Product/Process Change Notice (PCN)

PCN Number: PCN_IndUCF_20250428

Affected Series: WE-UCF

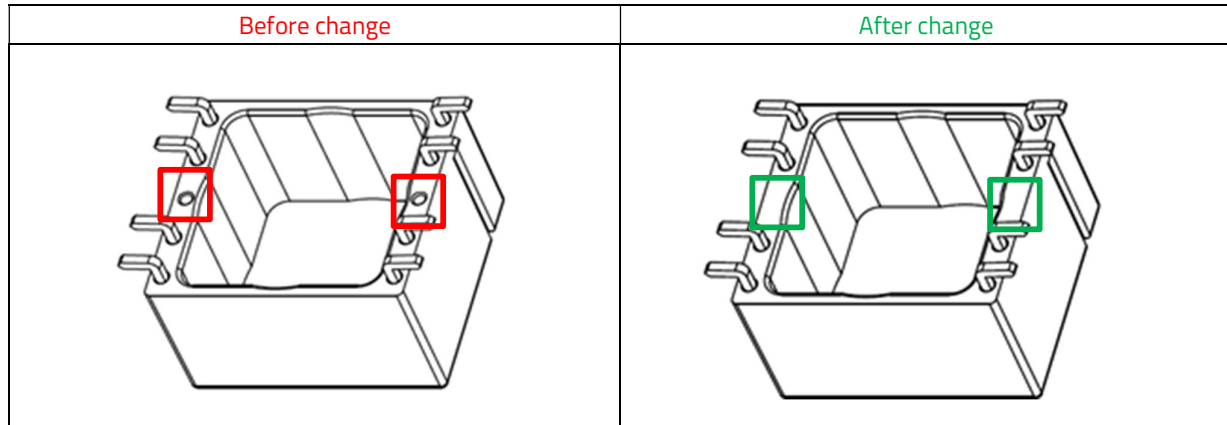
In order to enhance the product reliability, Würth Elektronik eiSos will close the extra holes in the plastic case of the component.

The dimensions of the component remain the same, as specified in the datasheet.
